## FCC Class II Permissive Change Request Letter

RE: FCC Permissive II Change Request for Company: Elec-Tech International Co., Ltd.  
FCC ID: XZH-5540312018

We are submitting an application for a class II permissive change to the FCC approval of the Company name: Elec-Tech International Co., Ltd., product description: LED Horticultural Luminaire, Model No.: 554031XX(XX=00~99) (FCC ID: XZH-5540312018, Original Grant Date: 08/28/2018). The transmitter module itself has not changed. Here are the changes:

Original motherboard

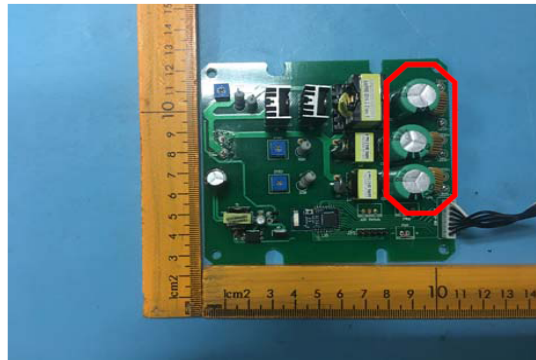
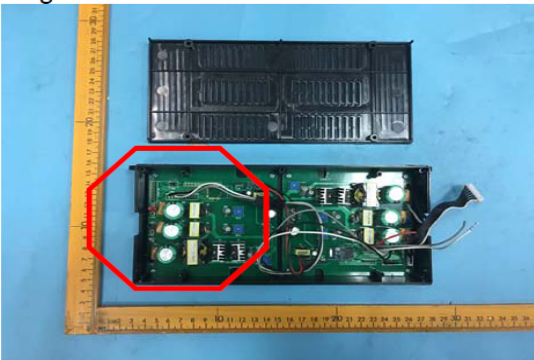
Only the power consumption has been Changed from 500W to 250W, 2 capacitors have been modified. No other modification has been made to the RF portion and no changes in the RF parameters. Please find the photos below.
